KINGSTON STEAM PLANT - ANNUAL ASH DISPOSAL AREA INSPECTION

KINGSTON STEAM PLANT - ANNUAL ASH DISPOSAL AREA INSPECTION

On the attached marked print of drawing 10N400, the different ash disposal areas and dikes are designated.

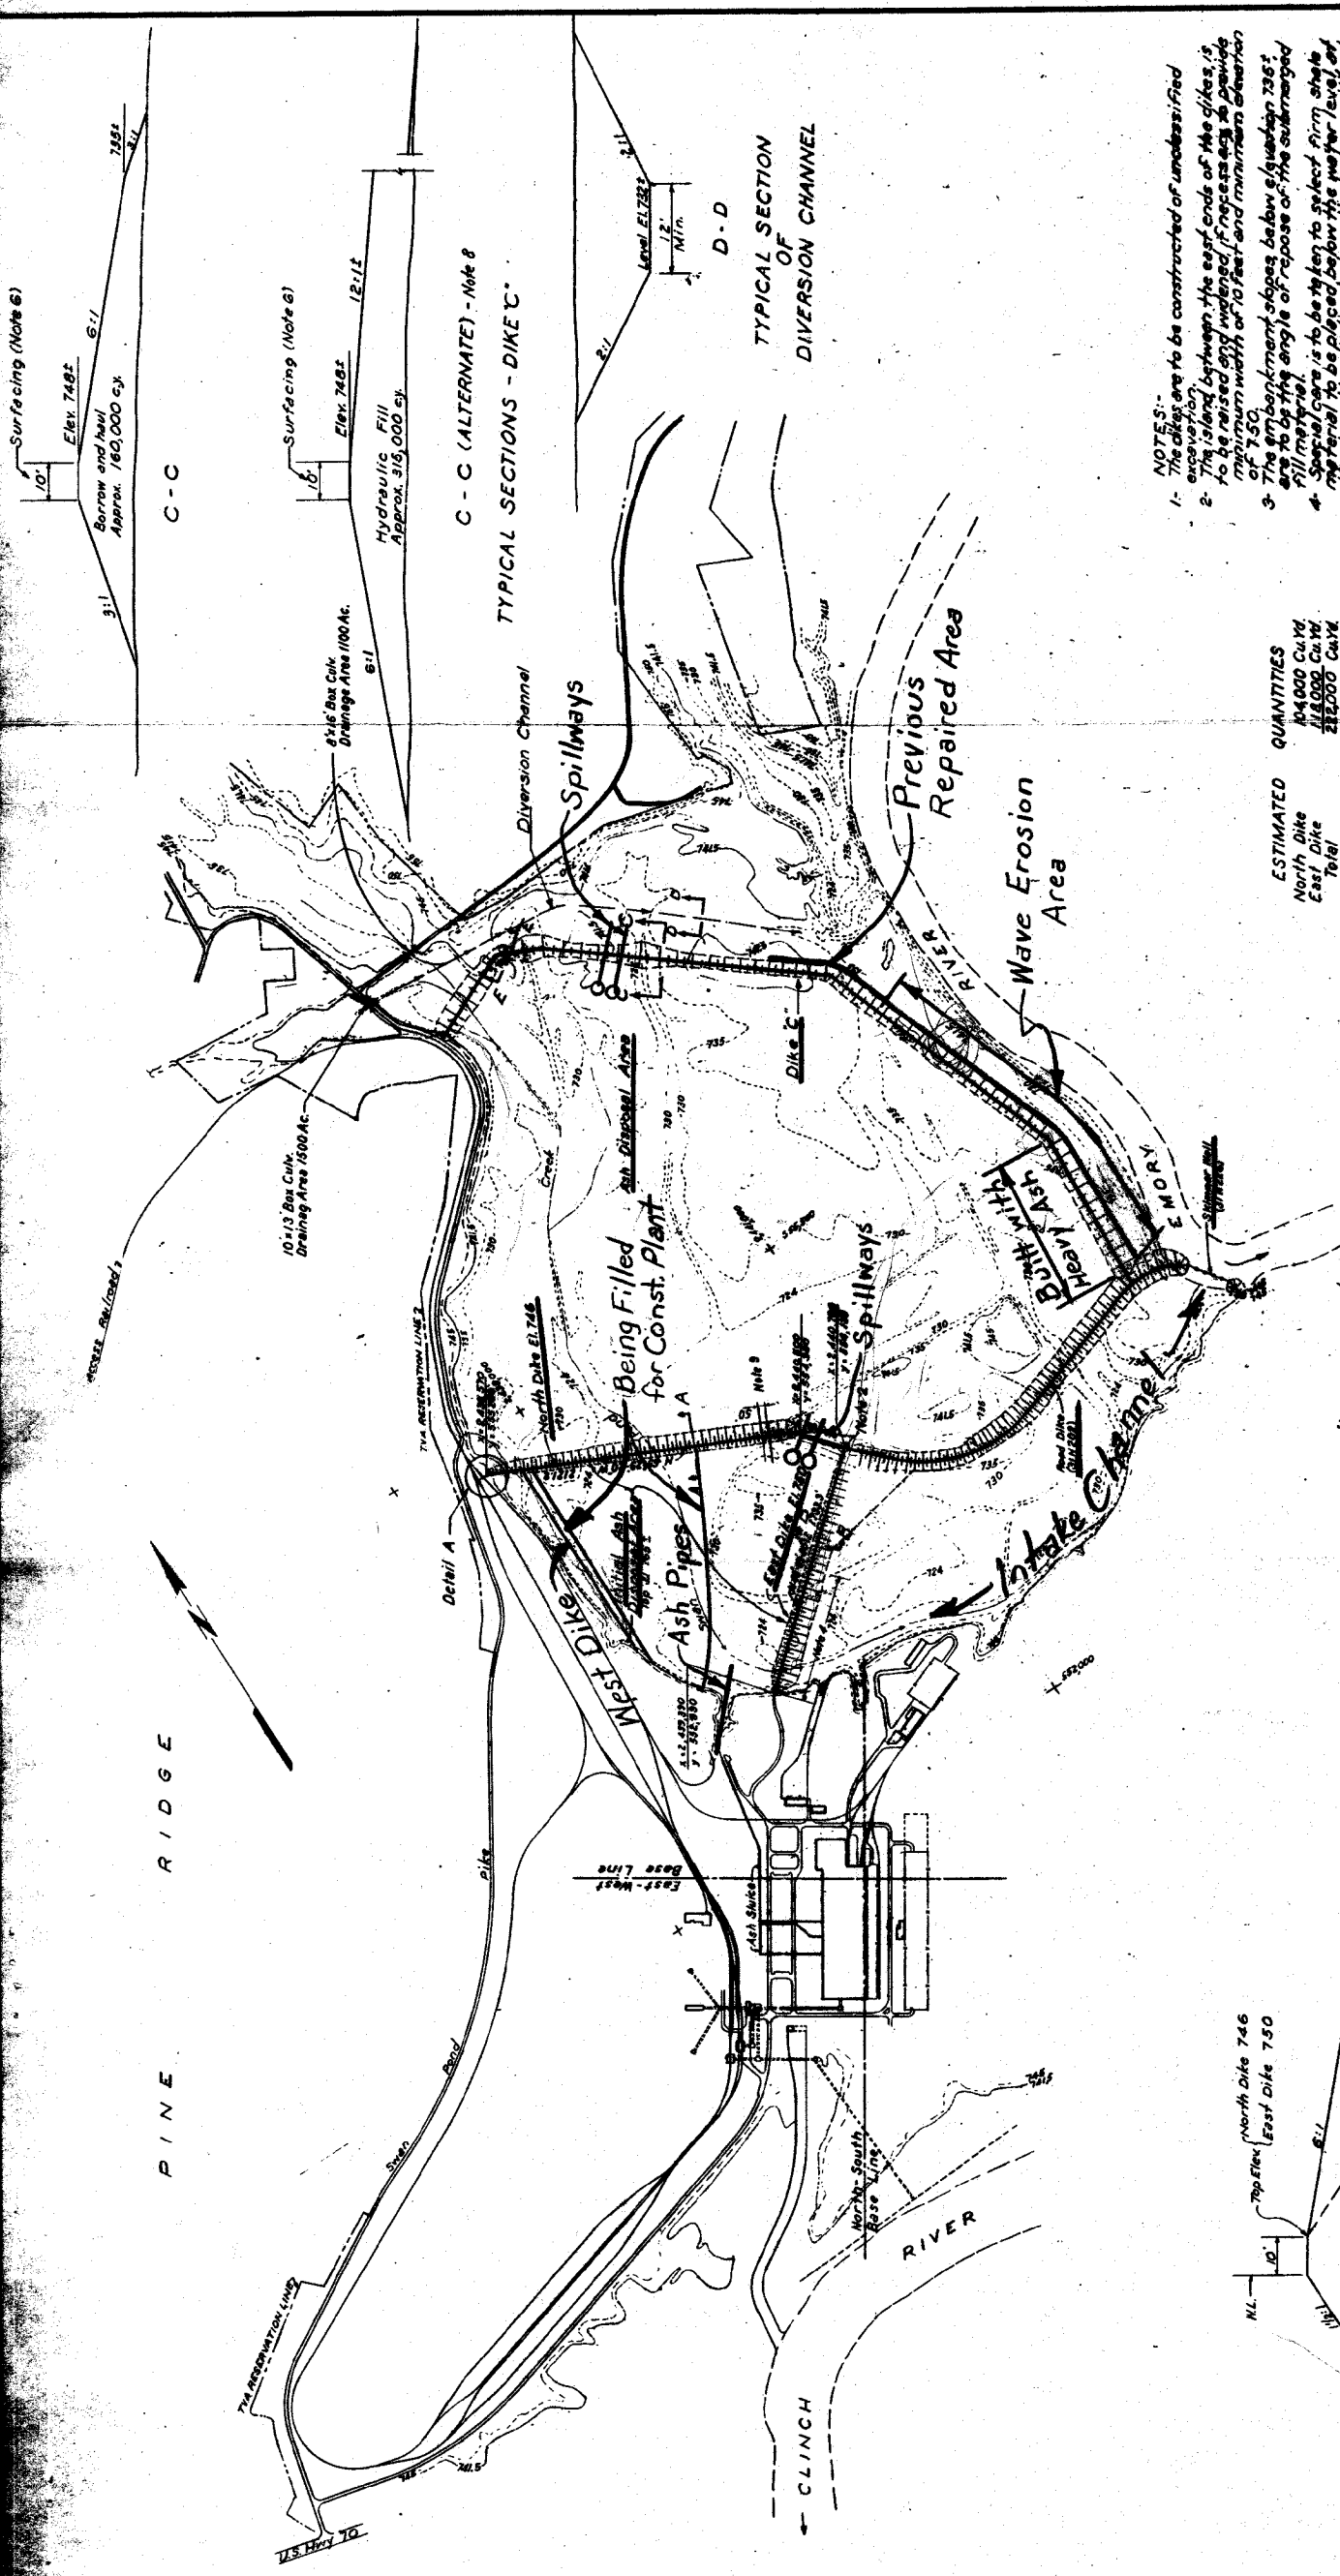
During the 1969 inspection, an area which eroded due to wave erosion was found on the outside toe of dike C, as shown on the print of drawing 10N400. This area was repaired in 1970 by rebuilding the toe with rockfill, and no further erosion of this area has taken place. Since 1970 the toe of dike C south of the original erosion has shown some small amounts of wave erosion, but none of any consequence until this inspection. The high flood waters and heavy rainfall of the past year have increased the erosion of the outside toe of dike C. The toe of the outside slope has eroded away leaving vertical slopes varying in height from one foot to approximately four feet. This area extends from the original (1969) erosion south to the junction of dike C with the road dikes. The new erosion will have to be repaired. Although the erosion is now not serious enough to be an immediate danger to the dike, further erosion can become so; and a long delay will only add to the expense of the repair. When Watts Bar Lake is drawn to coming winter elevation, another inspection of the erosion should be made to determine the full extent of repair needed. The plant personnel will coordinate the time of inspection with the Divisions of Power Production and Engineering Design.

With the above exception, all the dikes are in good condition with the tops smooth and sloped to the inside. The vegetation on the outside slopes is good with few exceptions. The main exception is the portion of dike C that was built with heavy ash, noted on the print of drawing 10N400. Seeding of this area is not planned at this time. The other exceptions are small isolated areas that are being worked on by plant personnel.

1. Rebuild, with rockfill, the toe of the outside slope of dike C where the erosion has taken place. The rebuilding is to be deferred until another joint inspection of the area can be made. This inspection is to be done at the earliest time when the elevation of Watts Bar Lake is such that a more detailed inspection can be made, approximately the middle of October. Plant personnel is to coordinate the time of inspection.
2. Remove the trash from the outside slopes of the dikes, especially the road dike.
